## Providence Bicycle and Pedestrian Advisory Commission

### **Staff Report: Proposed restriping of Harris – Olneyville - Ward 15 (For Action)**

*Presented at July 19, 2017 BPAC meeting*

#### **Project Map & Street View**

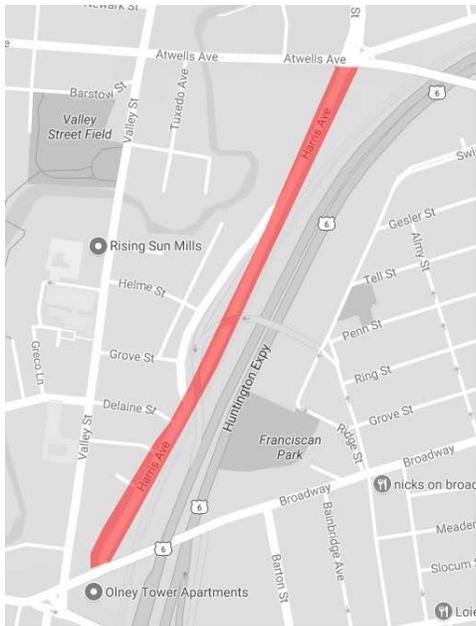
The proposed plans include a separated two-way bike lane along the east side of the road for the entire stretch of Harris Avenue from Broadway to Atwells Avenue. In order to fit the bike lanes, 22 out of 34 existing on street parking spaces on Harris Avenue between Broadway and School Street would be removed and 30 out of 64 existing on street parking spaces on Harris Avenue between School Street and Atwells Avenue would be removed.

- Green paint should be striped in dashed lanes across Broadway at the terminus of Harris Avenue to increase visibility of the bike lane.
- The traffic signal at the intersection of Harris and Atwells Avenues should be studied to determine what changes could be made to assist bike lane users traveling through the intersection.
